Amendments to the 2002 Water System Standards

SUBJECT: 2002 WATER SYSTEM STANDARDS AMENDMENT

For Oahu Only, the 2002 Water System Standards shall be amended as follows:

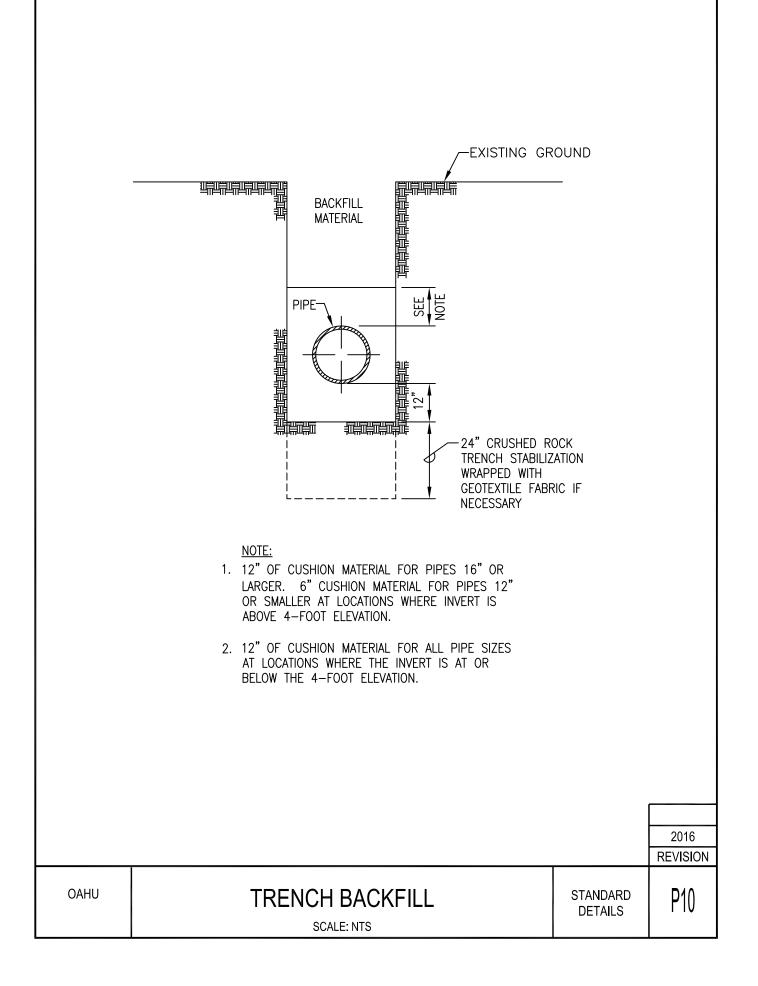
1. Delete Standard Detail P10 TRENCH BACKFILL and replace with the enclosed Standard Detail P10 TRENCH BACKFILL (2016 Revision) which reflects the increase in cushion material below the pipe to 12 inches.

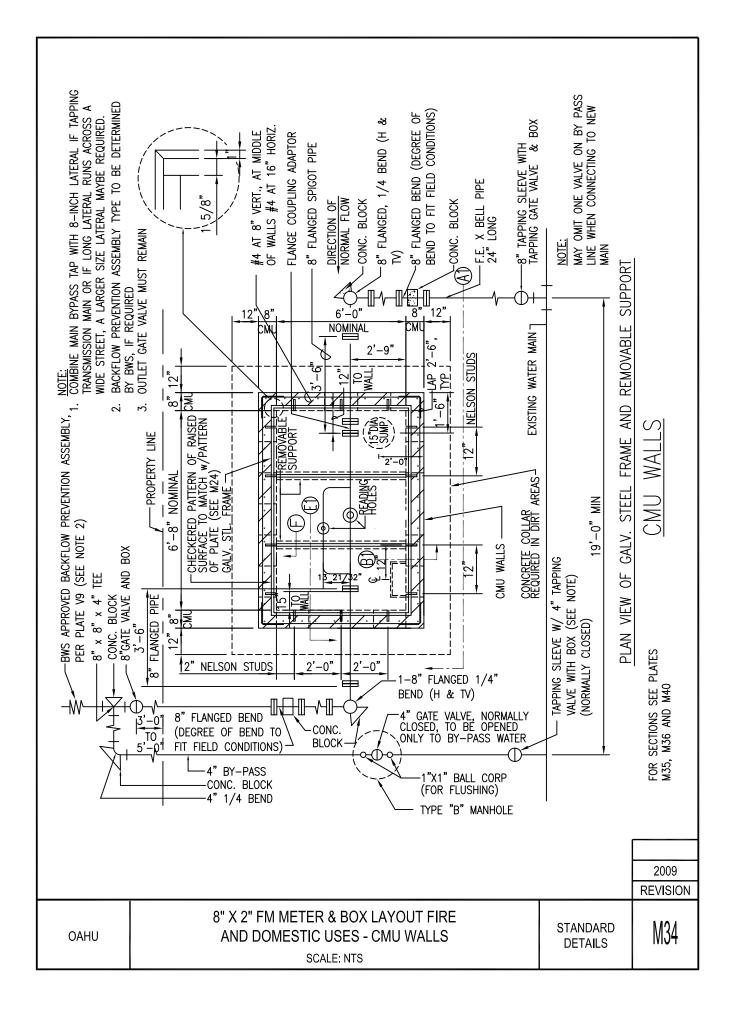
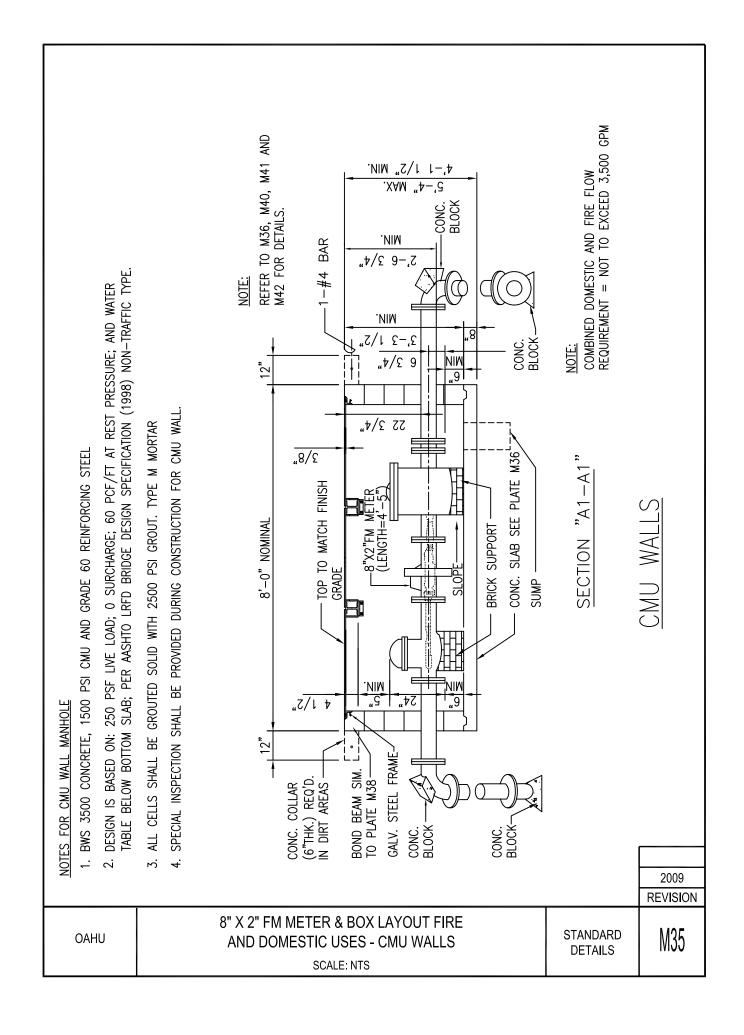
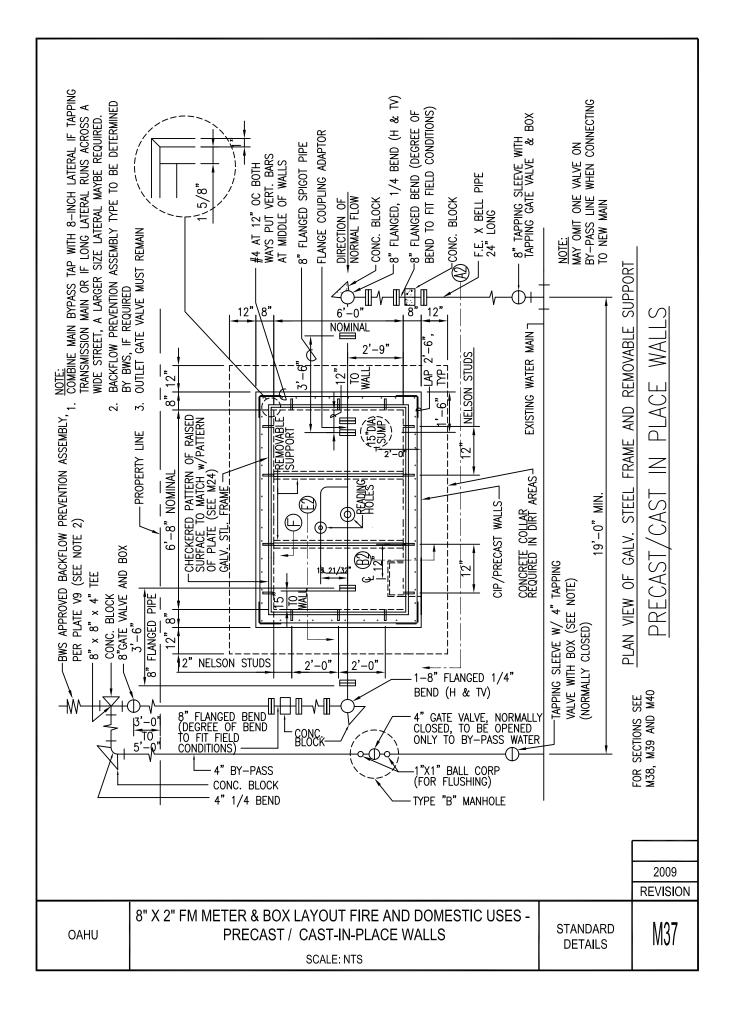
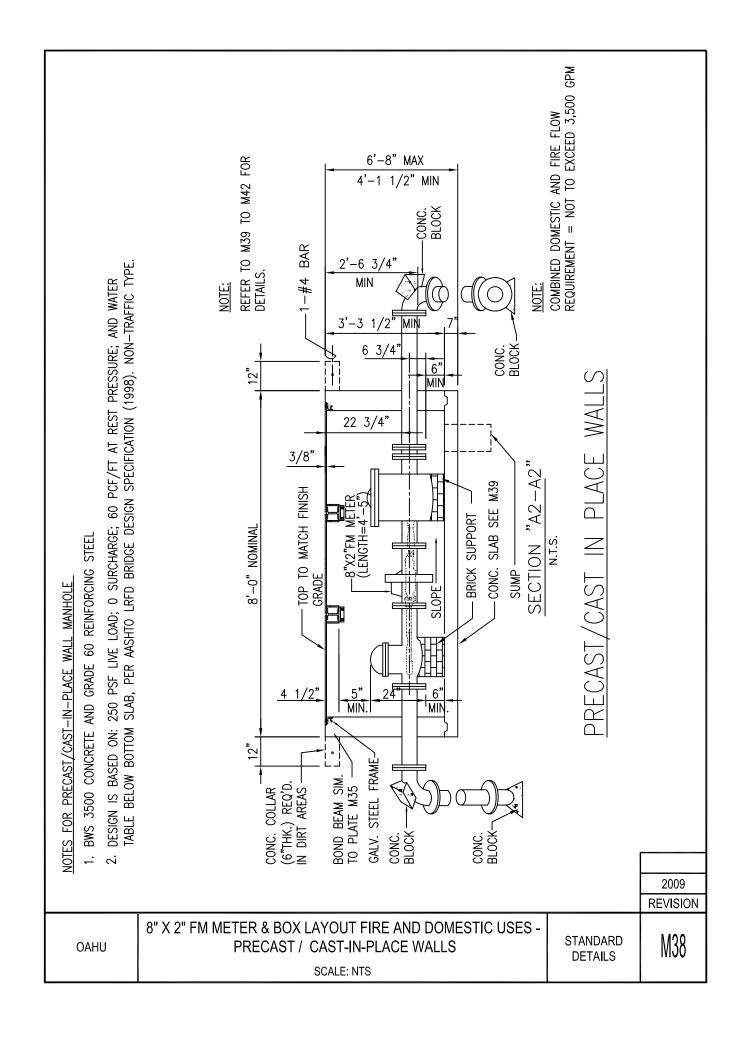
Replace the following details with the enclosed details (2009 Revision):

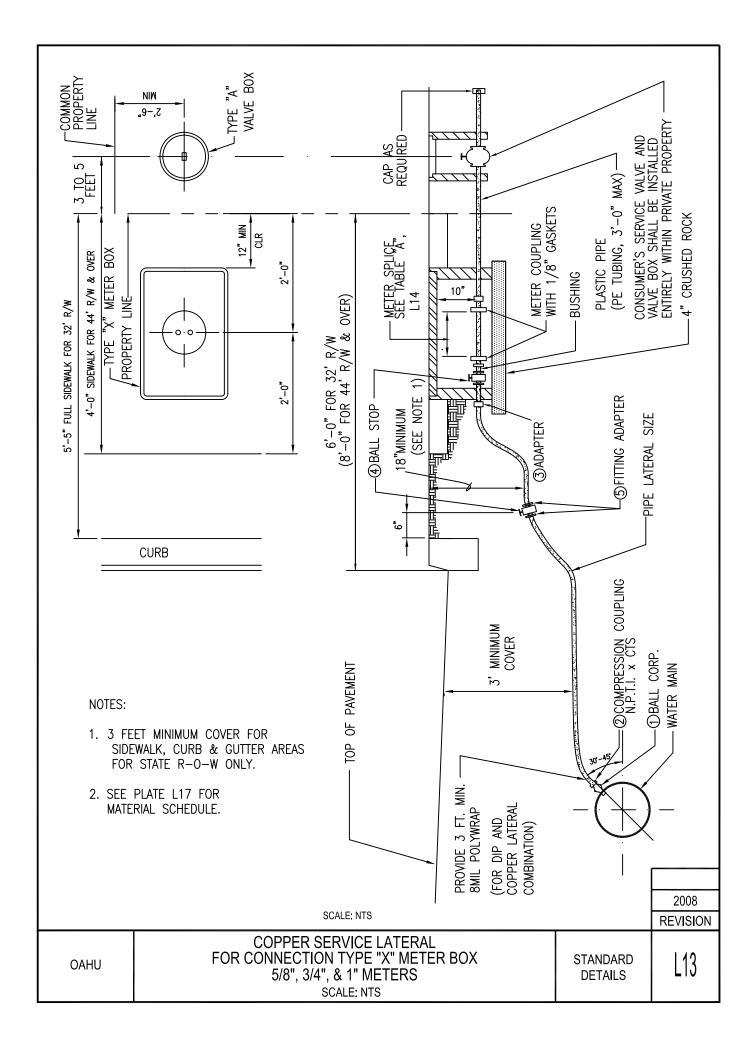
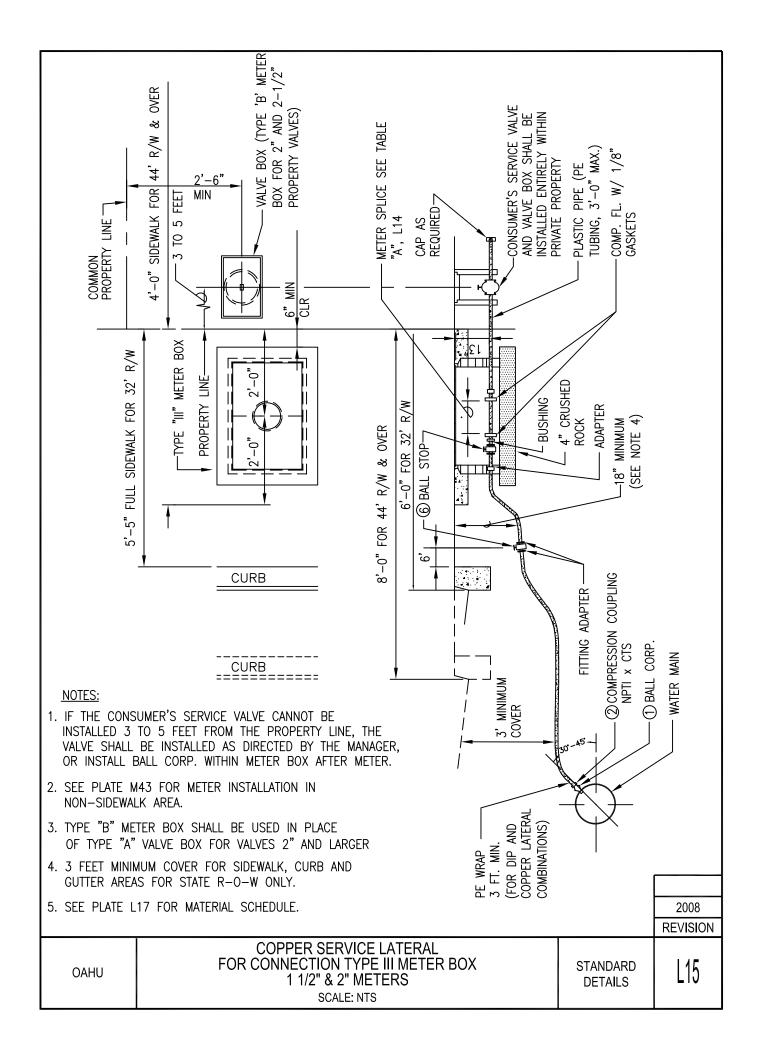
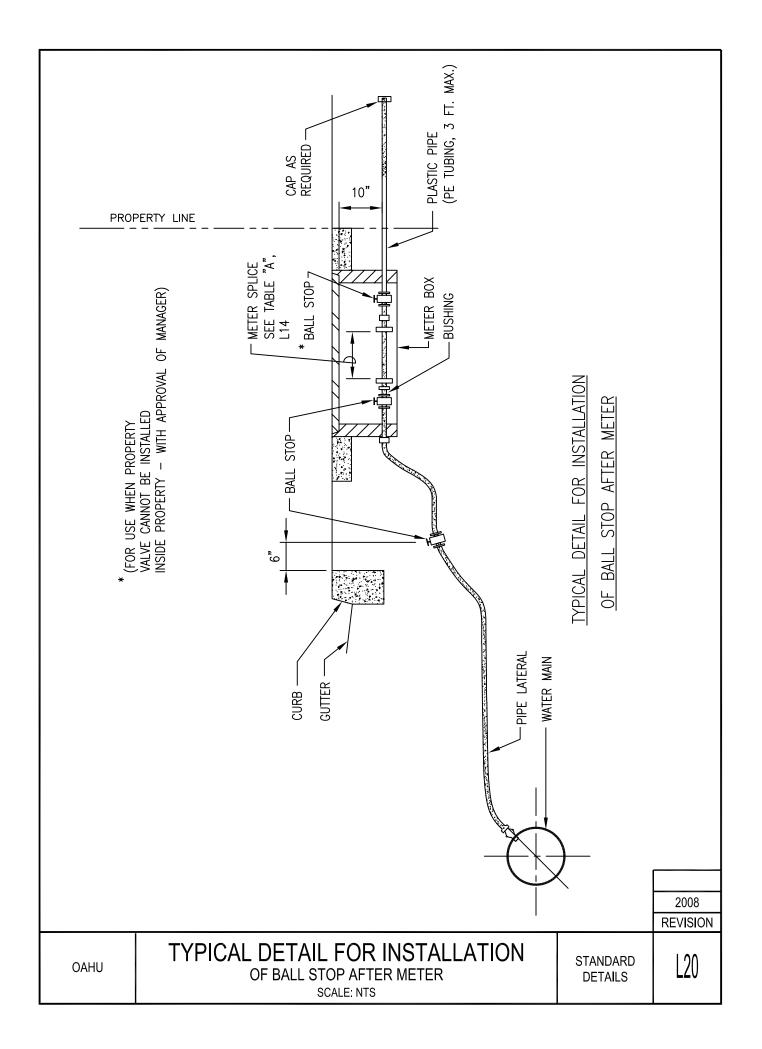
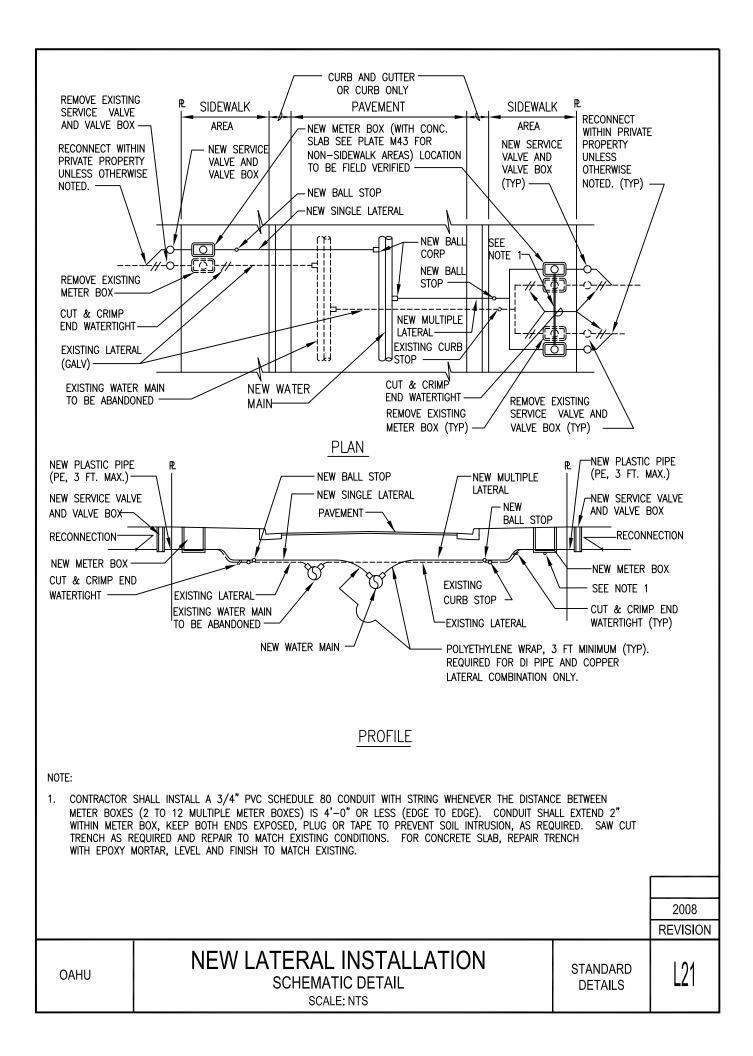
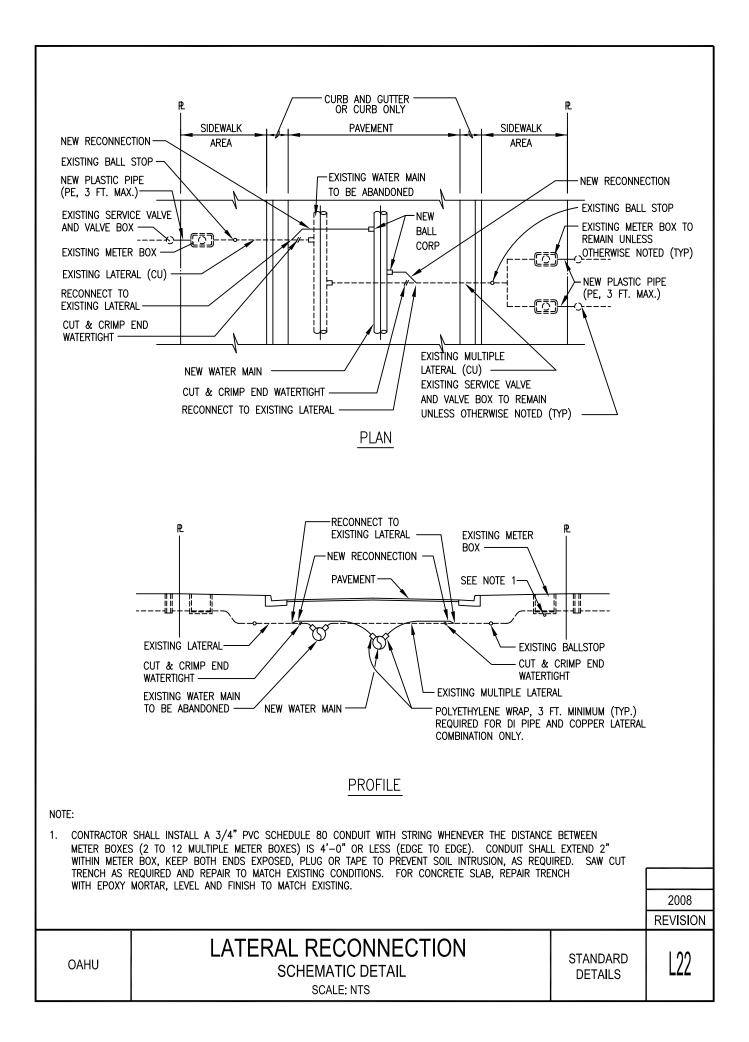
Replace the following details with the enclosed details (2008 Revision):

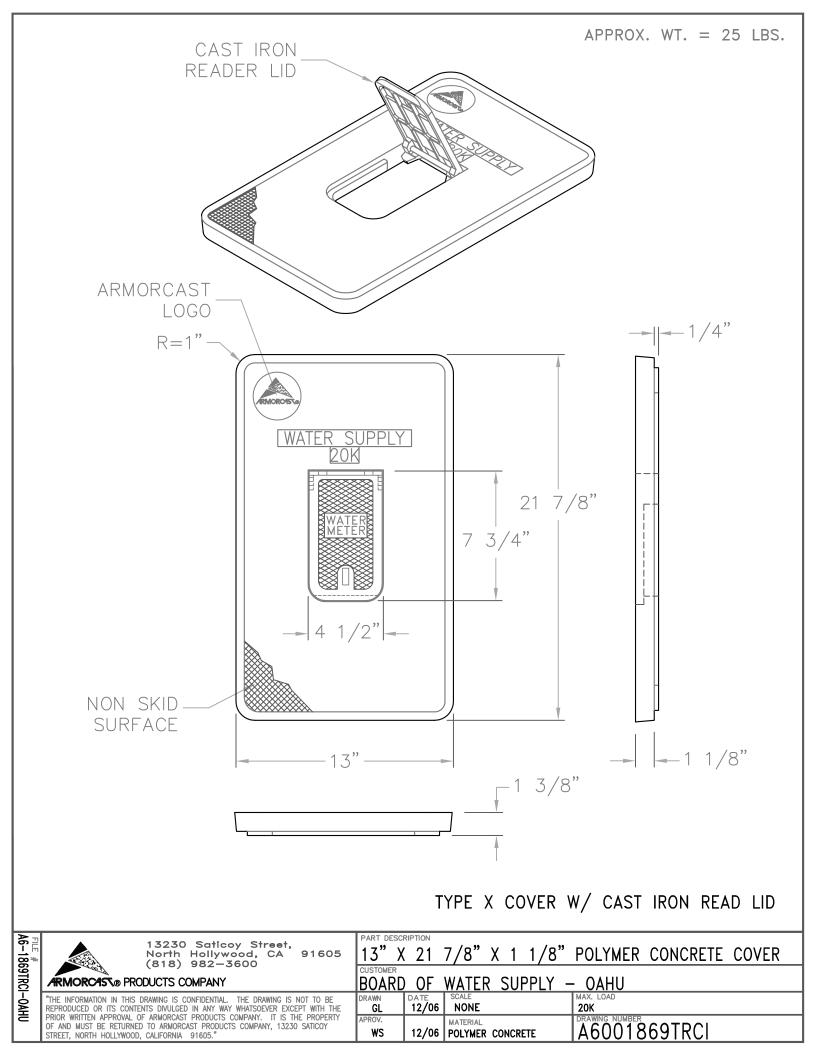
Effective immediately for Oahu only, all Polymer Concrete Type X Meter Box Covers shall be furnished with a cast iron reader lid as shown on the enclosed Drawing No. A6001869TRCI.

TYPICAL ELECTRONIC MARKER INSTALLATION

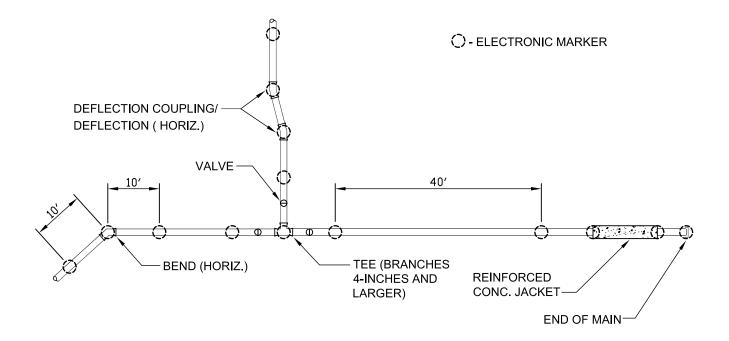
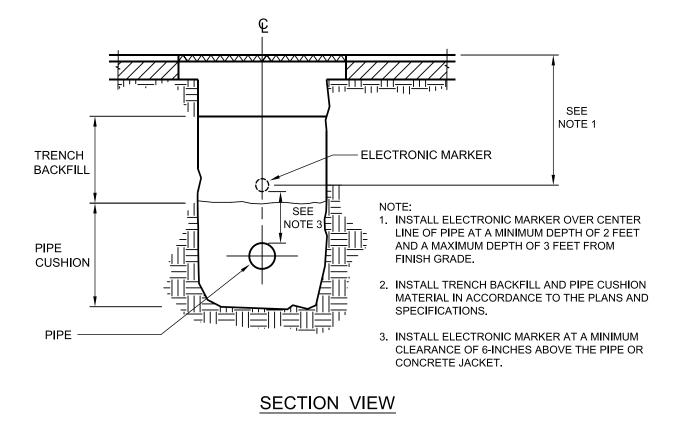
Installation of electronic markers shall be in accordance with the following:

- a. One marker at all changes in horizontal alignment.
 - (1) Tees with branches 4-inches and larger
 - (2) Bends
 - (3) Deflection couplings
 - (4) Deflections at joints
- b. One marker 10 feet prior to and one marker 10 feet after a change in horizontal alignment unless markers are required within the 10 feet distance.

- c. On straight runs, markers shall be placed at a maximum distance of 40 feet.
- d. One marker at the end of all mains.
- e. Markers at the beginning and end of all concrete jackets.
- f. Markers at the beginning and end of all sections of mains under concrete pavement.
- g. One marker at the connection of the new main to the existing main.
- h. Markers shall not be placed at crossings with electrical duct lines, gas lines or telephone duct lines. Install markers at a minimum clearance of 5 feet from these utility crossings.
- 3. Testing
